## Request for Information ("RFI")

**PROJECT:**  
2022 WMS Makerspace and PPS Project

**RFI No.** 1

# SELF-REGULATING ELECTRIC HEAT TRACE SYSTEM DETAIL

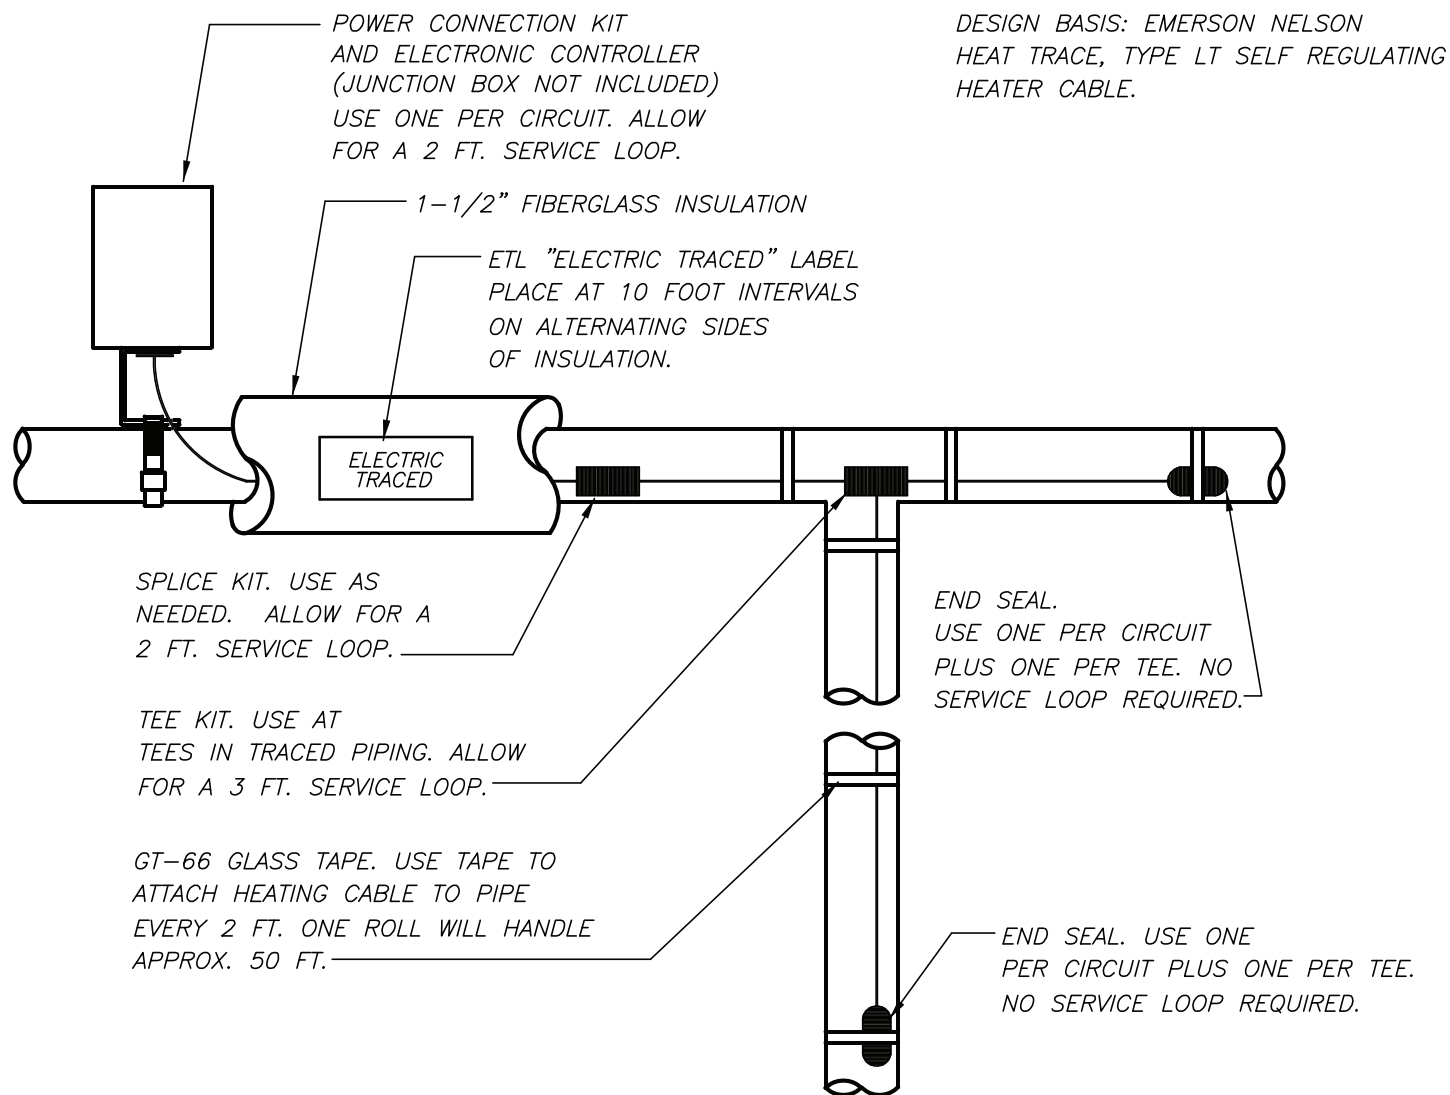
RFI DESCRIPTION: **Drawing P201 – Detail 3 – Mentions Heat Trace and insulate piping; there is no detail showing the extent of the heat trace nor is there a manufacturer listed in the specifications.**

RFI #5 – Please provide a detail for the heat trace along with a manufacturers make and model number along with ratings detail.

See the attached heat trace detail.

DESIGN BASIS: EMERSON NELSON  
HEAT TRACE, TYPE LT SELF REGULATING  
HEATER CABLE.
